Accessibility Survey

City of Downey Iowa Steet & Brookshire Avenue

Date of Inspection
4/30/2017

Disability Access Consultants

Sidewalks , Change in Level : Change in Level Non Beveled

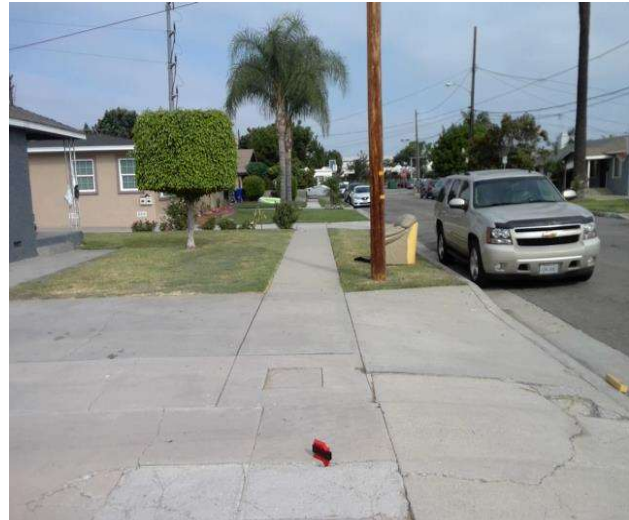
There is a change in elevation greater than recommended value.

On-Site Finding 0.87 inches

Ensure that the change in elevation is within the recommended value.

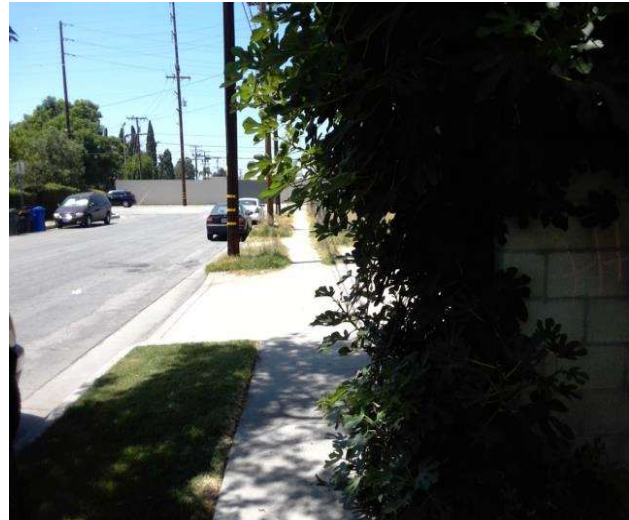
Sidewalk width at the obstruction is not compliant.

On-Site Finding 24.00 inches

Sidewalk width at the obstruction shall have the recommended value.

Sidewalks , Change in Level : Change in Level Non Beveled

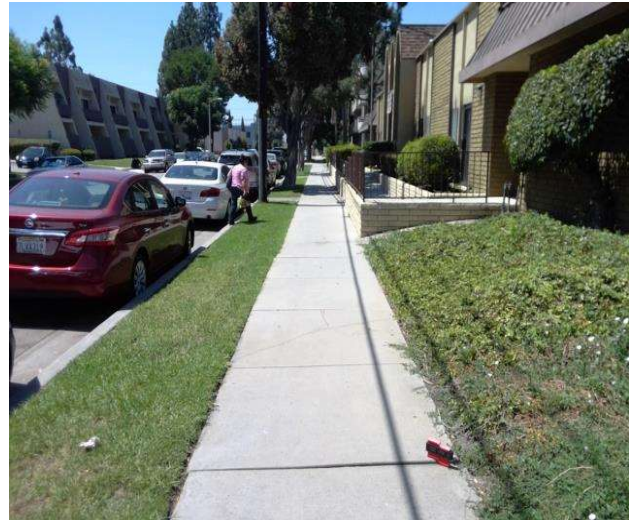
There is a change in elevation greater than recommended value.

On-Site Finding 0.62 inches

Ensure that the change in elevation is within the recommended value.

Sidewalks , Change in Level : Change in Level Non Beveled

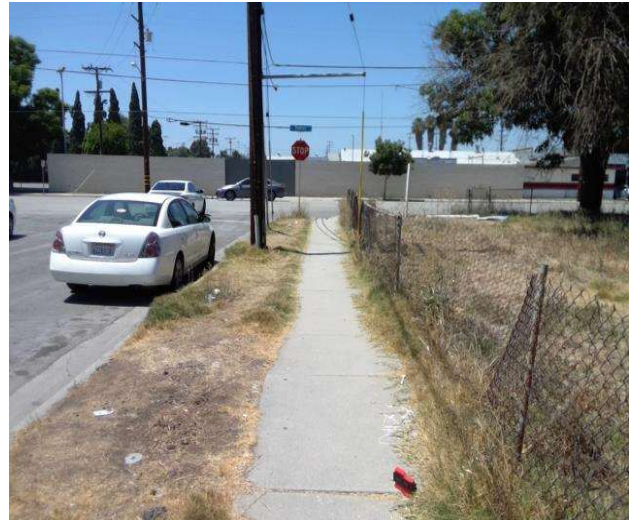
There is a change in elevation greater than recommended value.

On-Site Finding 0.62 inches

Ensure that the change in elevation is within the recommended value.

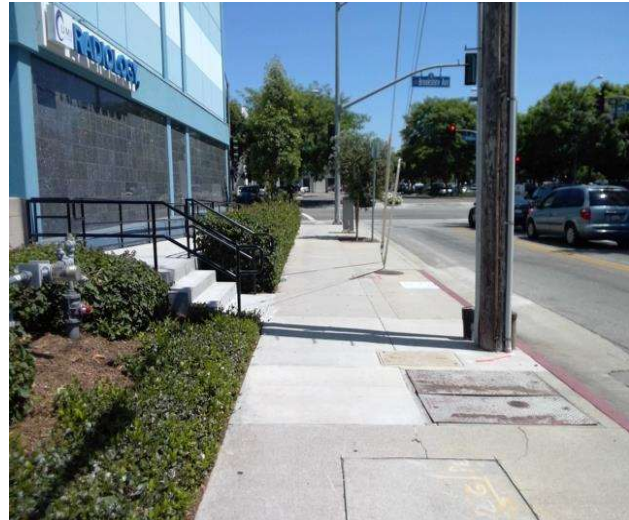
Sidewalk cross slope is not compliant.

On-Site Finding 3.70 percent for 80.00 feet

Repave the sidewalk surface with the recommended cross slope.

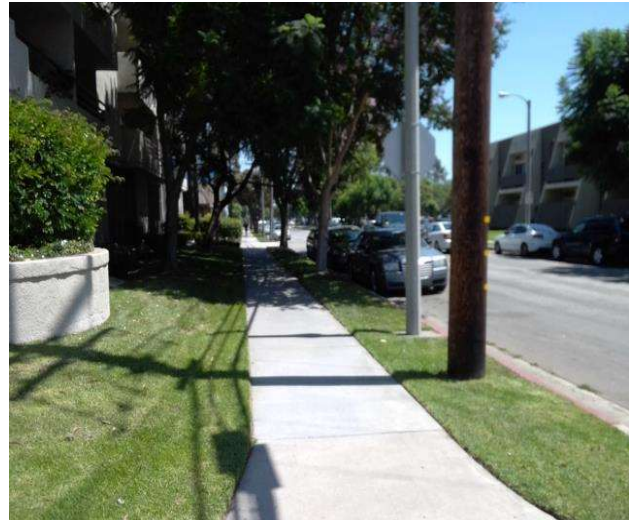
Sidewalk cross slope is not compliant.

On-Site Finding 3.60 percent for 213.00 feet

Repave the sidewalk surface with the recommended cross slope.

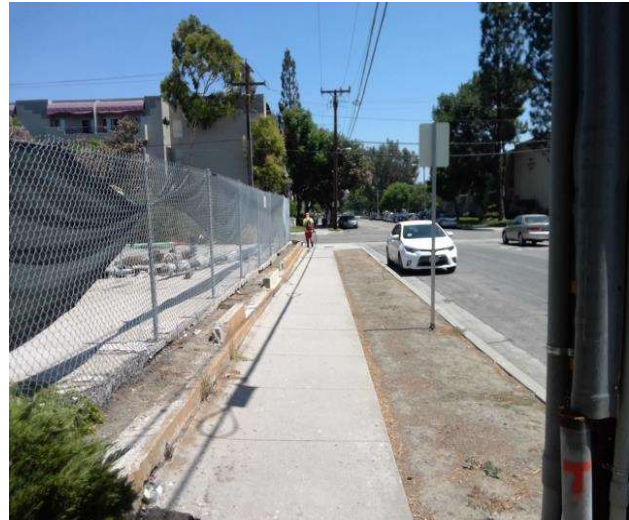
Sidewalk cross slope is not compliant.

On-Site Finding 5.90 percent for 60.00 feet

Repave the sidewalk surface with the recommended cross slope.

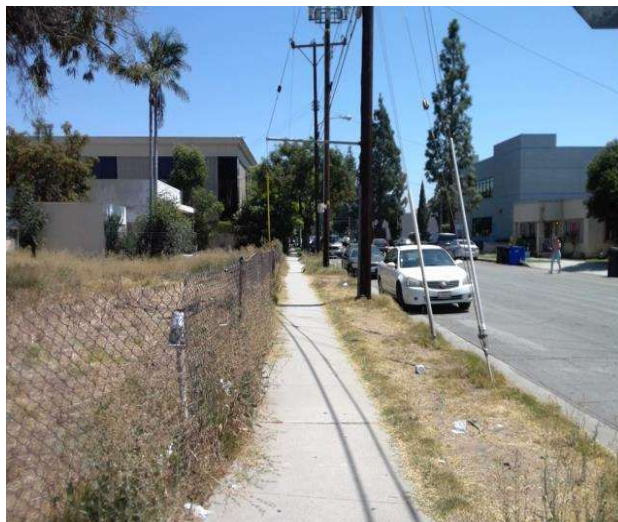
Sidewalk cross slope is not compliant.

On-Site Finding 3.80 percent for 64.00 feet

Repave the sidewalk surface with the recommended cross slope.

Sidewalks , Change in Level : Change in Level Non Beveled

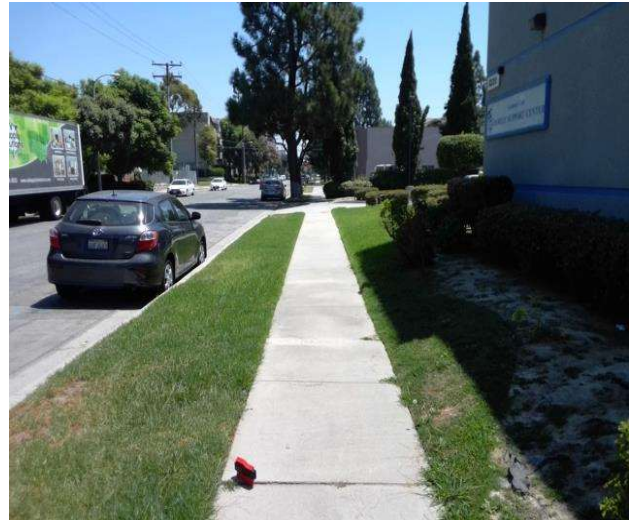
There is a change in elevation greater than recommended value.

On-Site Finding 0.50 inches

Ensure that the change in elevation is within the recommended value.

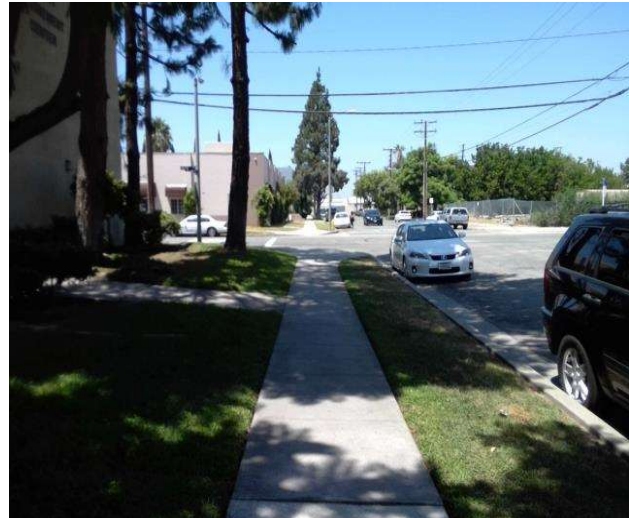
Sidewalk cross slope is not compliant.

On-Site Finding 3.70 percent for 59.00 feet

Repave the sidewalk surface with the recommended cross slope.
